**Categories:** Public comment on 16-25 TIP

I write to provide input on transportation priorities such as included in the draft 2016-2025 MTIP. My input here will address plans associated with upgrades to NC54 between I-40 in Durham and Meadowmont in Chapel Hill. I live beside this NC 54 corridor, on Celeste Circle in the Eastwood Park neighborhood, and much of my understanding of transportation plans in this corridor come from the Collector Street Plan Meetings, the NC54/I-40 Corridor Study Report, and from my reading of projects U5774A through U5774F.

**Figure 6-10: Potential Access Reconfiguration for Celeste Circle**

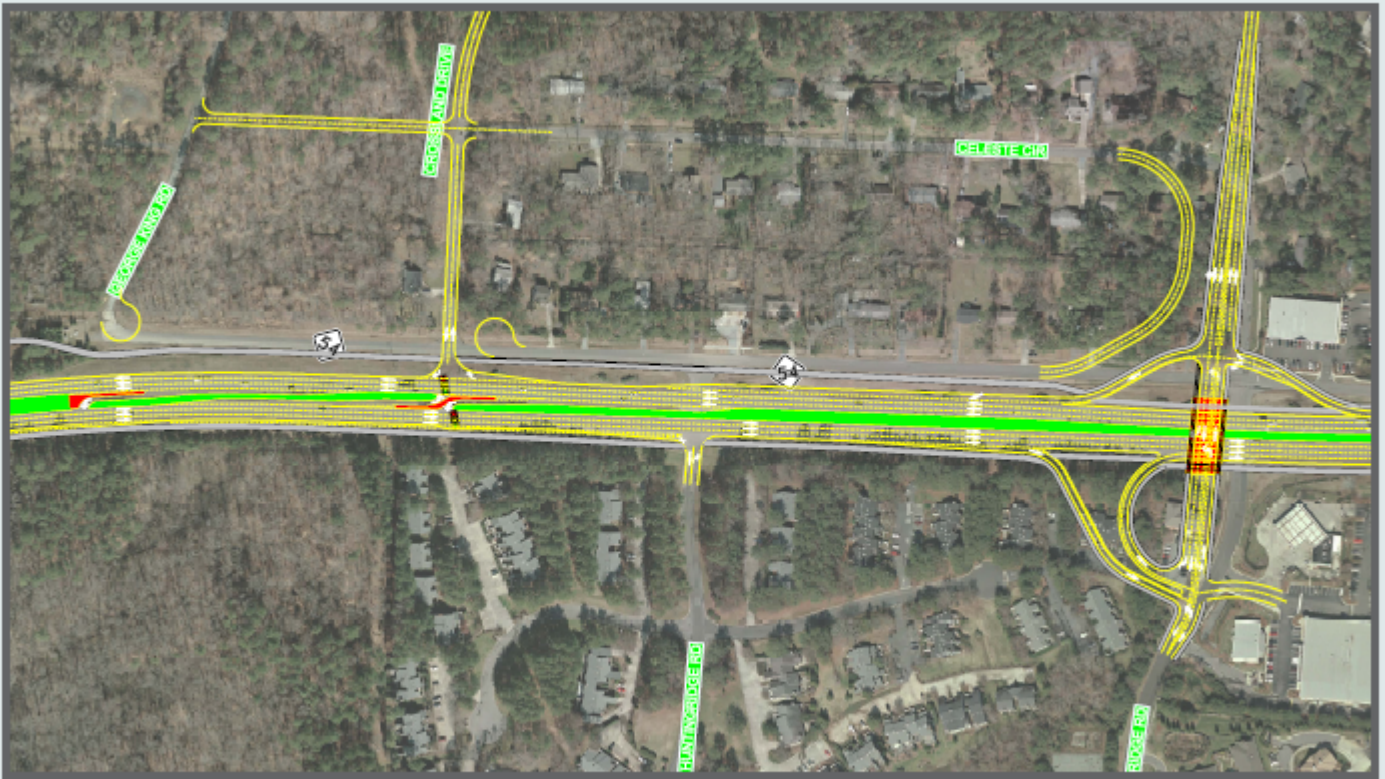
Please work to try to limit our street to one access point in the event a large neighborhood, Leigh Village, were to be built behind our neighborhood. Having 2 access points, at the East end and West ends would cause extra cross through traffic in our neighborhood and greatly diminish the safety of our neighborhood.
